# TASPEN RIDGE - STOCKP COLORADO SPRINGS, COLORADO DING & EROSION CONTROL PLANS

EPC's EDARP File Number: CDR2312

|  | TRAILS AT ASPEN RIDGE - STOCKPILE                          |                  |                          |            |                       |                    |                     |  |
| PRELIMINARY  | CONSTRUCTION DRAWINGS<br>GRADING AND EROSION CONTROL PLANS |                  |                          |            |                       |                    |                     |  |

|  | TRAILS AT ASPEN RIDGE - STOCKPILE                          |                  |                          |            |                       |                    |                     |  |
|--|--|------------------|--------------------------|------------|-----------------------|--------------------|---------------------|--|
| FOR AND ON BEHALF OF<br>ATRIX DESIGN GROUP, INC.<br>PROJECT No. 23.886.078 | DESIGNED BY: 1<br>DRAWN BY:<br>CHECKED BY:                 | NMS<br>KGI<br>RA | SCALE<br>HORIZ.<br>VERT. | N/A<br>N/A | DATE ISSUED:<br>SHEET | MAY 2023<br>1 OF 5 | drawing no.<br>TS01 |  |

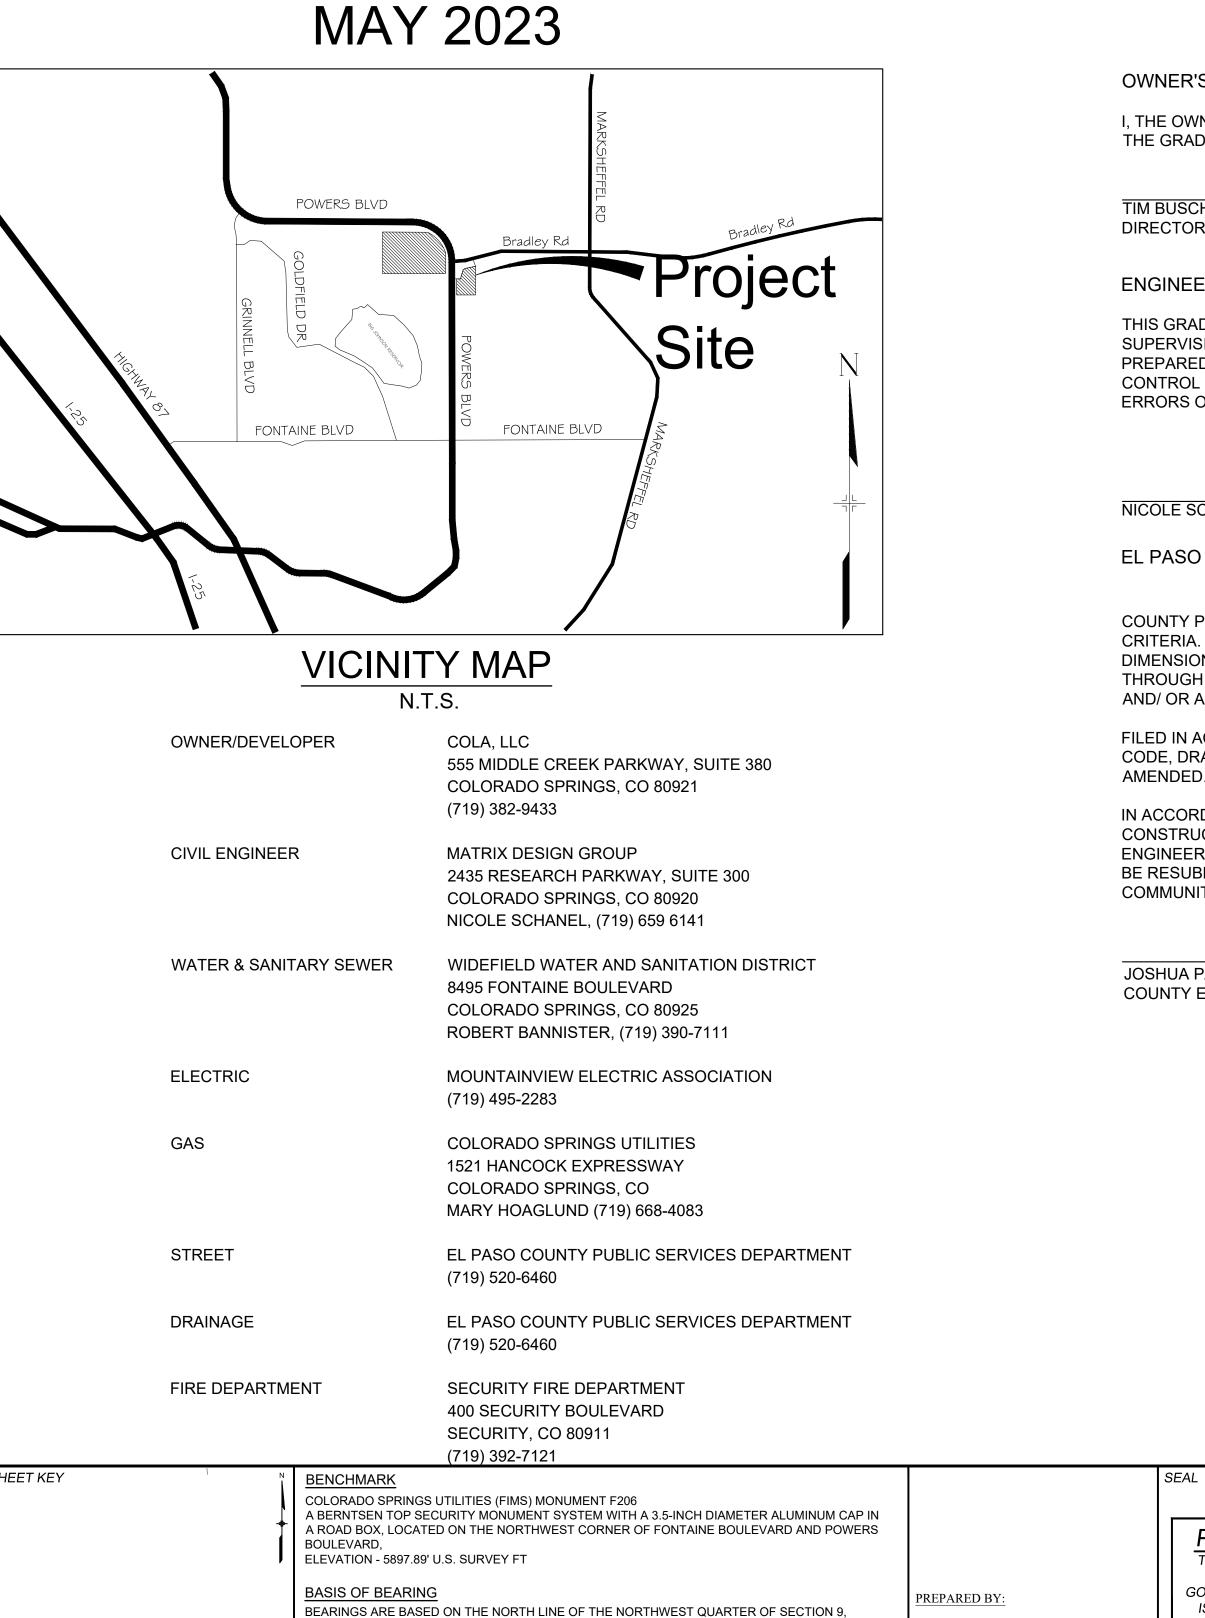
Add text:

Will need signatures for commercial site and owners on west side of Powers, as grading operations will be taking part on their property.

| FOR AND ON BEHALF OF                                | DESIGNED BY:             | NMS        | SCALE           |            | DATE ISSUED: | MAY 2023 | DRAWING No. |
|---|--------------------------|------------|-----------------|------------|--------------|----------|-------------|
| MATRIX DESIGN GROUP, INC.<br>PROJECT No. 23.886.078 | DRAWN BY:<br>CHECKED BY: | TRS<br>NMS | HORIZ.<br>VERT. | N/A<br>N/A | SHEET        | 3 OF 5   | GEC01       |

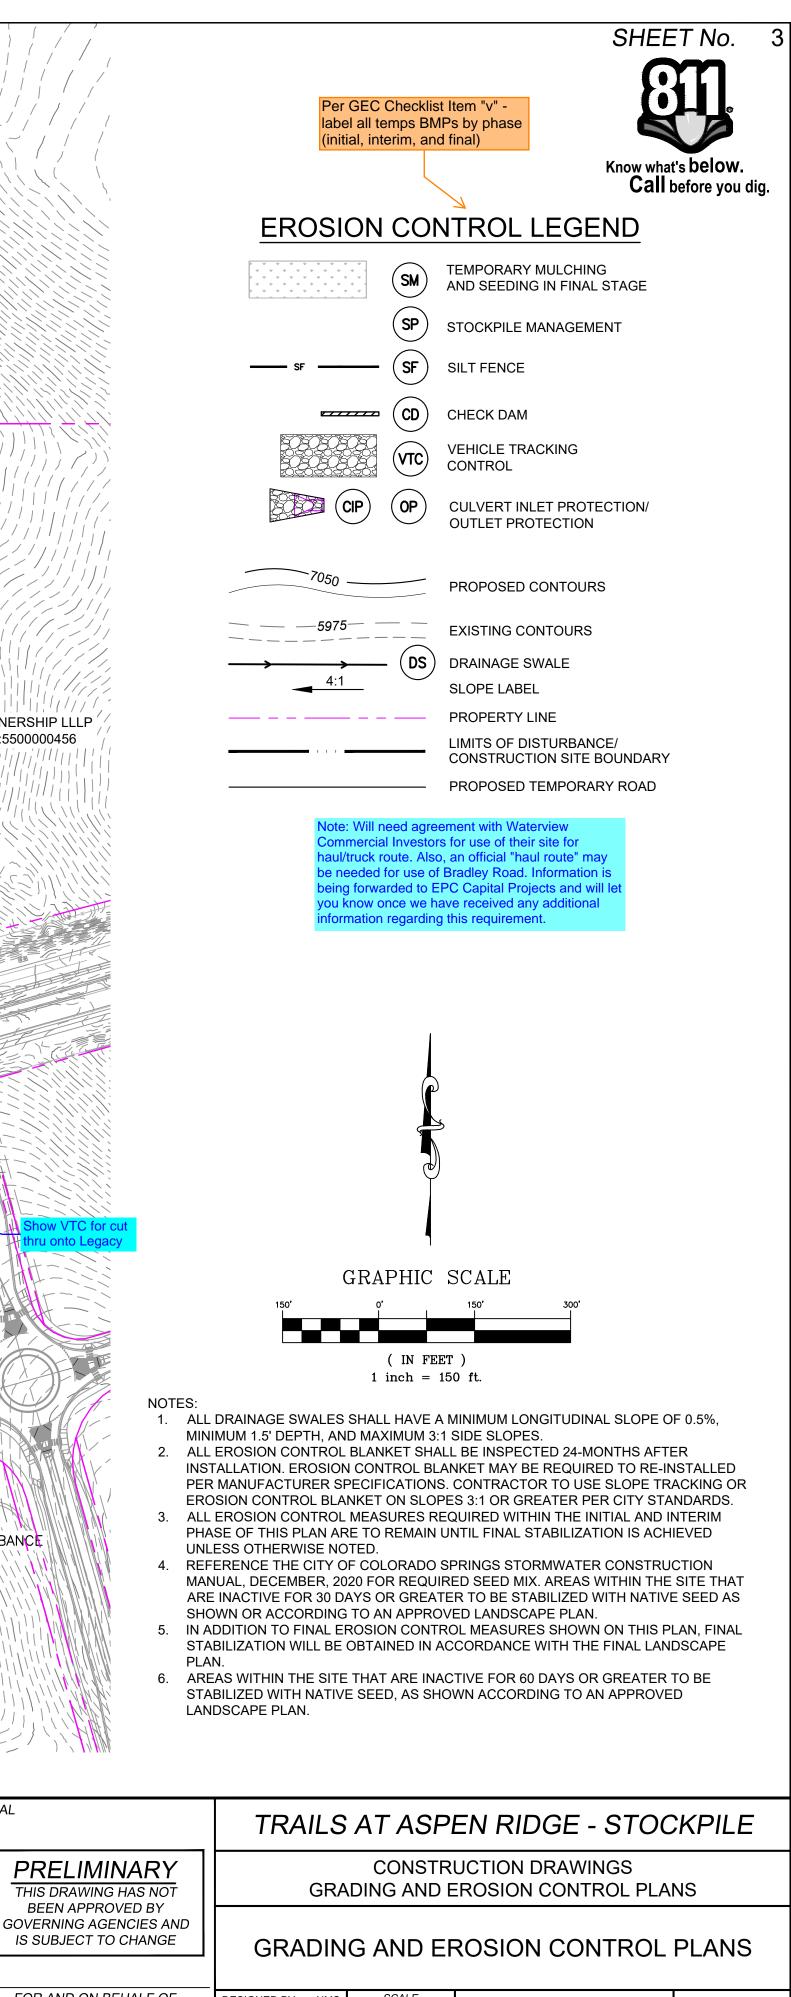
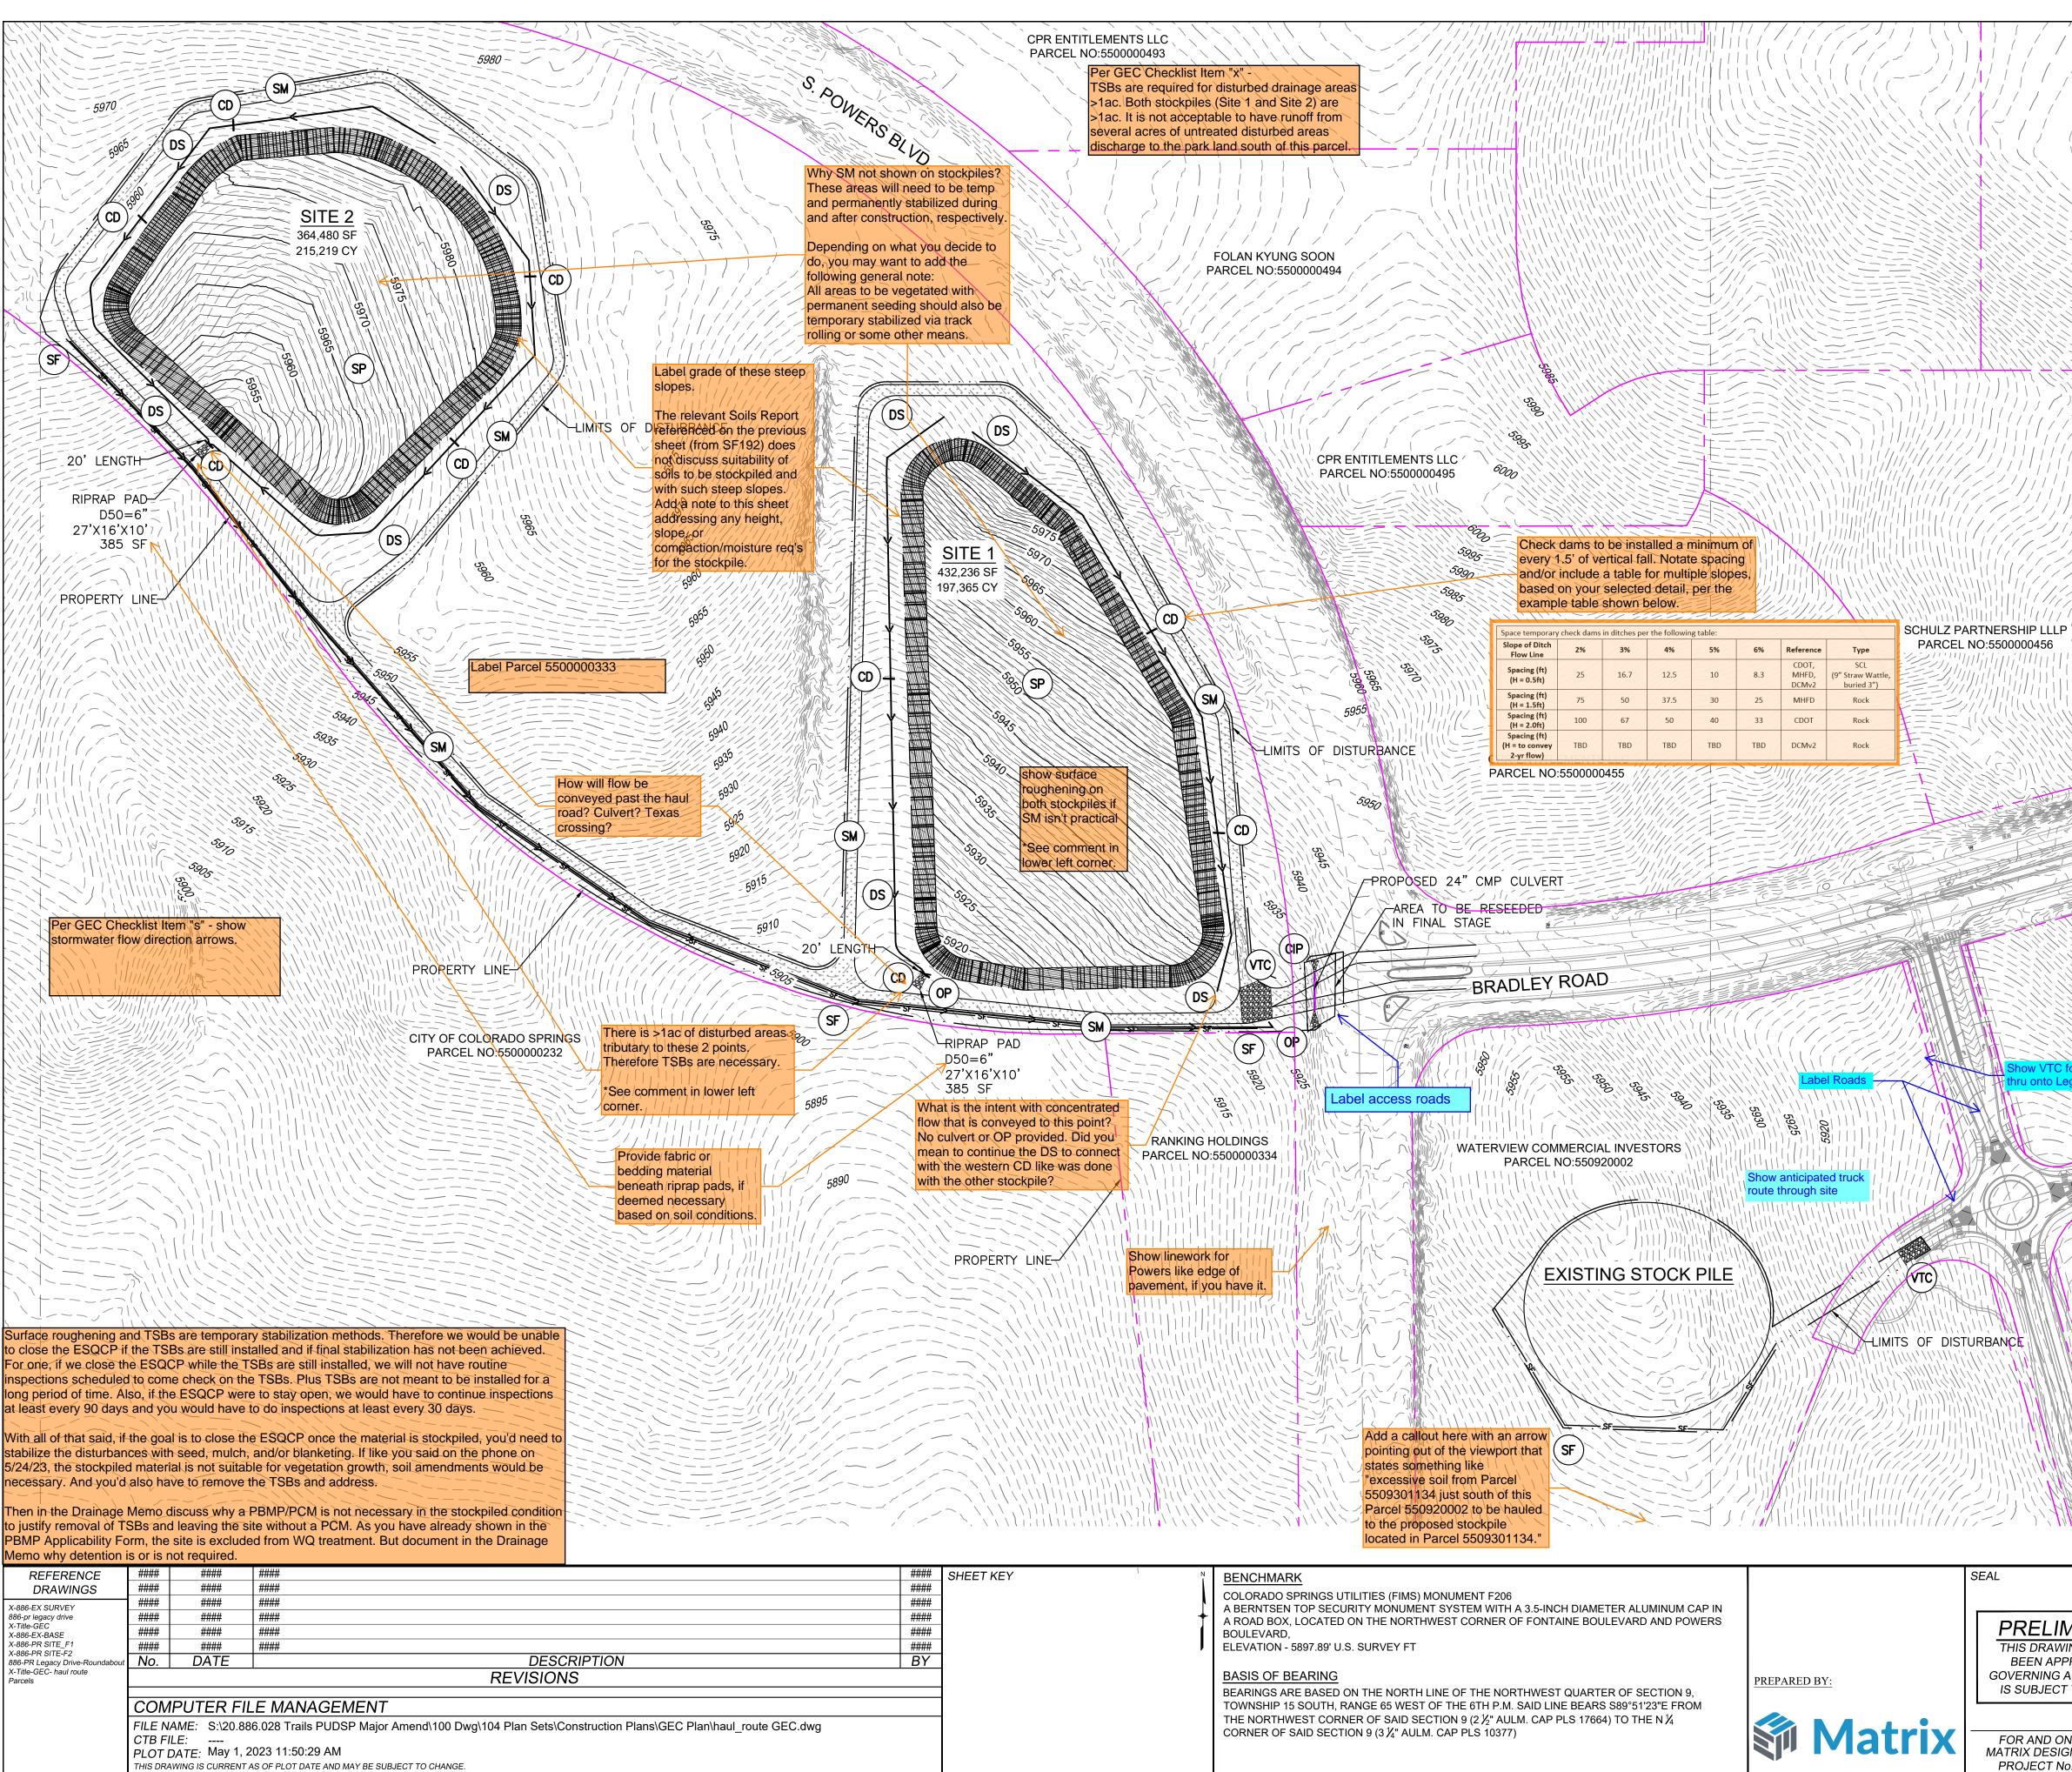
| Subject: Callout<br>Page Label: [3] 3 GEC01<br>Author: Carlos<br>Date: 5/17/2023 5:06:32 PM<br>Status:<br>Color:<br>Layer:<br>Space:                     | Label access roads   |
| Subject: Callout<br>Page Label: [3] 3 GEC01<br>Author: CDurham<br>Date: 5/24/2023 4:40:17 PM<br>Status:<br>Color:<br>Layer:<br>Space:                    | Show VTC for cut thru onto Legacy  |
| Subject: Callout<br>Page Label: [3] 3 GEC01<br>Author: CDurham<br>Date: 5/24/2023 4:40:45 PM<br>Status:<br>Color: Layer:<br>Space:                       | Label Roads  |

Subject: SW - Textbox Page Label: [3] 3 GEC01 Author: Glenn Reese - EPC Stormwater Date: 5/16/2023 1:34:34 PM Status: Color: ■ Layer: Space: Add a callout here with an arrow pointing out of the viewport that states something like "excessive soil from Parcel 5509301134 just south of this Parcel 550920002 to be hauled to the proposed stockpile located in Parcel 5509301134."

Label Parcel 550000333

Show linework for Powers like edge of pavement, if you have it.

Per GEC Checklist Item "v" - label all temps BMPs by phase (initial, interim, and final)

Subject: SW - Textbox with Arrow Page Label: [3] 3 GEC01 Author: Glenn Reese - EPC Stormwater Date: 5/16/2023 3:30:14 PM Status: Color: ■ Layer: Space: What is the intent with concentrated flow that is conveyed to this point? No culvert or OP provided. Did you mean to continue the DS to connect with the western CD like was done with the other stockpile?

Check dams to be installed a minimum of every 1.5' of vertical fall. Notate spacing and/or include a table for multiple slopes, based on your selected detail, per the example table shown below.

Label grade of these steep slopes.

The relevant Soils Report referenced on the previous sheet (from SF192) does not discuss suitability of soils to be stockpiled and with such steep slopes. Add a note to this sheet addressing any height, slope, or compaction/moisture req's for the stockpile.

Subject: SW - Textbox with Arrow Page Label: [3] 3 GEC01 Author: Glenn Reese - EPC Stormwater Date: 5/16/2023 3:32:02 PM Status: Color: ■ Layer: Space: Why SM not shown on stockpiles? These areas will need to be temp and permanently stabilized during and after construction, respectively.

Depending on what you decide to do, you may want to add the following general note: All areas to be vegetated with permanent seeding should also be temporary stabilized via track rolling or some other means.

How will flow be conveyed past the haul road? Culvert? Texas crossing?

Provide fabric or bedding material beneath riprap pads, if deemed necessary based on soil conditions.

Surface roughening and TSBs are temporary stabilization methods. Therefore we would be unable to close the ESQCP if the TSBs are still installed and if final stabilization has not been achieved. For one, if we close the ESQCP while the TSBs are still installed, we will not have routine inspections scheduled to come check on the TSBs. Plus TSBs are not meant to be installed for a long period of time. Also, if the ESQCP were to stay open, we would have to continue inspections at least every 90 days and you would have to do inspections at least every 30 days.

With all of that said, if the goal is to close the ESQCP once the material is stockpiled, you'd need to stabilize the disturbances with seed, mulch, and/or blanketing. If like you said on the phone on 5/24/23, the stockpiled material is not suitable for vegetation growth, soil amendments would be necessary. And you'd also have to remove the TSBs and address.

Then in the Drainage Memo discuss why a PBMP/PCM is not necessary in the stockpiled condition to justify removal of TSBs and leaving the site without a PCM. As you have already shown in the PBMP Applicability Form, the site is excluded from WQ treatment. But document in the Drainage Memo why detention is or is not required.

There is >1ac of disturbed areas tributary to these

2 points. Therefore TSBs are necessary.

26 Show anticipated truck route through site Subject: Text Box Page Label: [3] 3 GEC01 Author: CDurham Date: 5/24/2023 4:41:20 PM Status: Color: Layer: Space:

Show anticipated truck route through site

Note: Will need agreement with Waterview Commercial Investors for use of their site for haul/truck route. Also, an official "haul route" may be needed for use of Bradley Road. Information is being forwarded to EPC Capital Projects and will let you know once we have received any additional information regarding this requirement.
